**HISTORIC PRESERVATION COMMISSION
SEPTEMBER 10, 2020
ASSEMBLY HALL
395 MAGNOLIA ROAD
PINEHURST, NORTH CAROLINA
4:30 PM**

COA 2020-00113

To: Historic Preservation Commission
From: Peter Hughes, Senior Planner
CC: Darryn Burich, Planning and Inspections Director
Kelly Brown, Administrative Specialist
Date: September 2, 2020
Subject: Major COA Request for 190 Linden Road (COA-2020-00113)

Existing Front Elevation

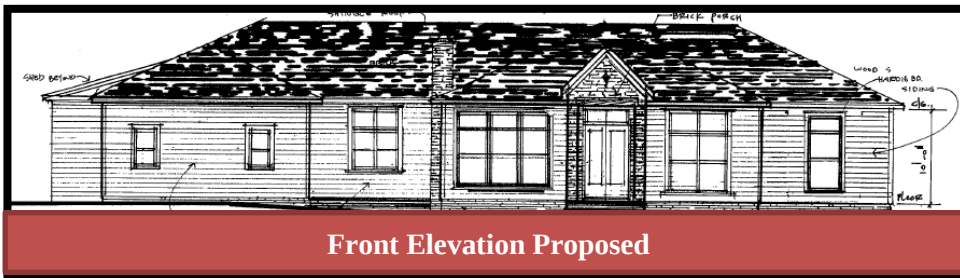
Based on the submitted elevations the proposed addition would be compatible with the architectural character of the structure and would appear to be similar to other structures within the Historic District. The elevations also include introduction of new architectural detail and character to structure, such as a brick accent around the front door and proposed front courtyard, both of which would appear similar to other structures within the proposed Historic District.

The applicant has indicated that the square footage of the home would increase from 2400 to 4200 square feet, which is a 75 percent increase in square footage. The height of the addition and proposed roof configuration appear to match or complement the existing structure. The structure as proposed would appear to be similar in scale to other structures within the Historic District.

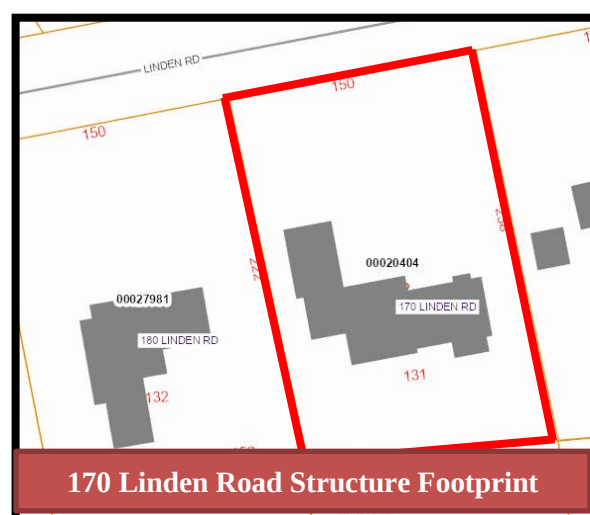
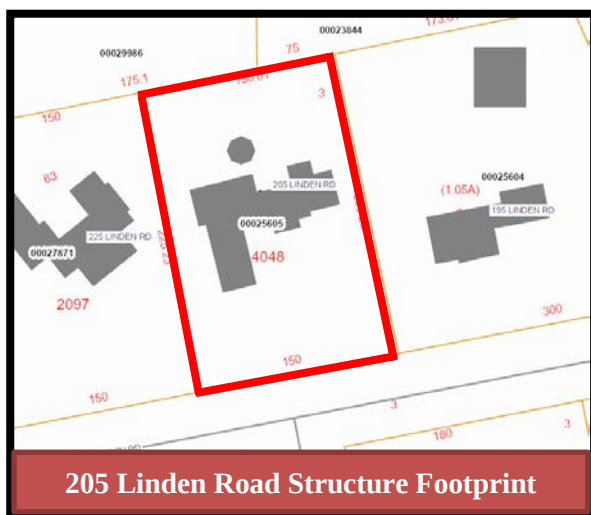
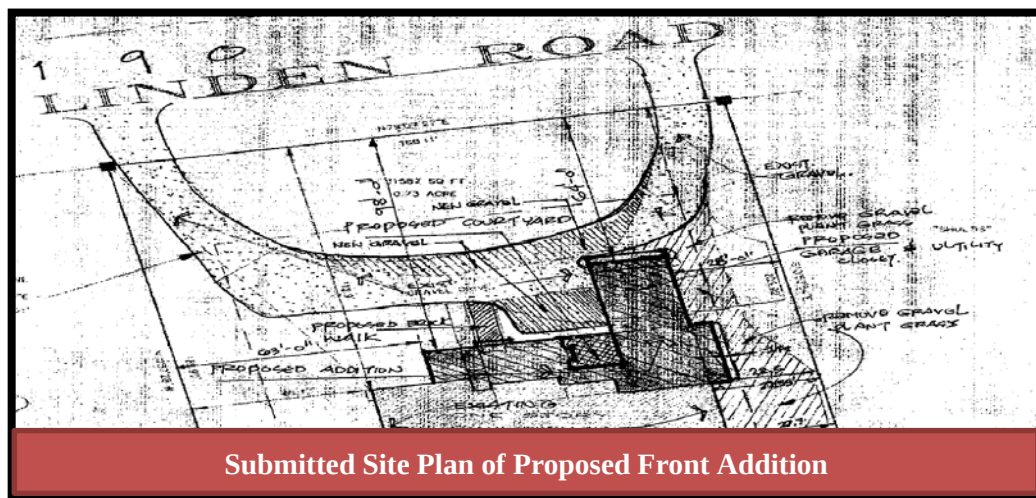
The proposed addition will be a front addition, which is not compliant with the Historic District Guidelines. Based on the size of the addition and the placement of the existing structure, a rear or side yard addition would have been difficult. Front additions or building wings that extend past the principal façade are not uncommon within the Historic District. There are multiple structures throughout the district that have a similar building footprint. Both 175 Linden Road and 205 Linden Road have front additions and are located within 300 feet of the subject property. The Commission has the ability to approve a request that is not consistent with the Guidelines if the request is deemed to be congruous with the Historic District.

The proposed front addition will alter the current aesthetic of the street facing elevation. As previously stated, the subject structure was constructed in the late 1950s and is not listed as a contributing structure. The Commission must determine if the proposed addition is impacting any character defining features of the primary structure.

PROPOSED SITE PLAN

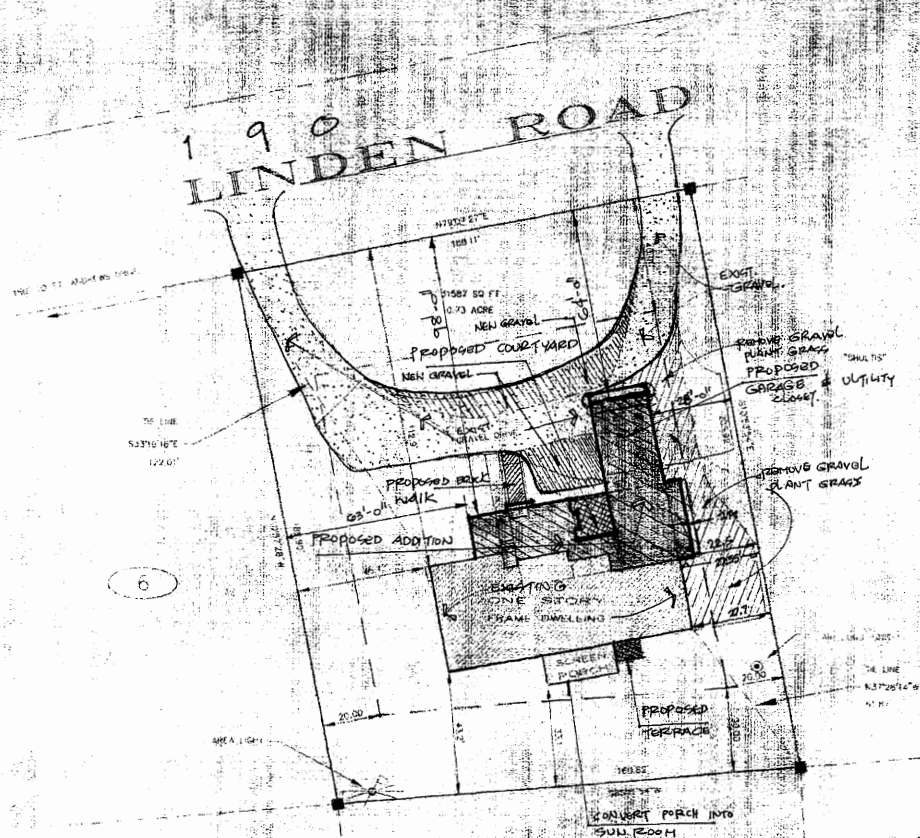
The applicant is proposing two patios. One front yard patio that is called out as a courtyard and one rear yard patio that is called out as a terrace on the submitted site plan. Neither patio addition should negatively affect the character of the structure.

As previously stated, one rear yard patio and one front yard patio have been proposed. The front yard patio is to function more like a courtyard based on the submitted material.
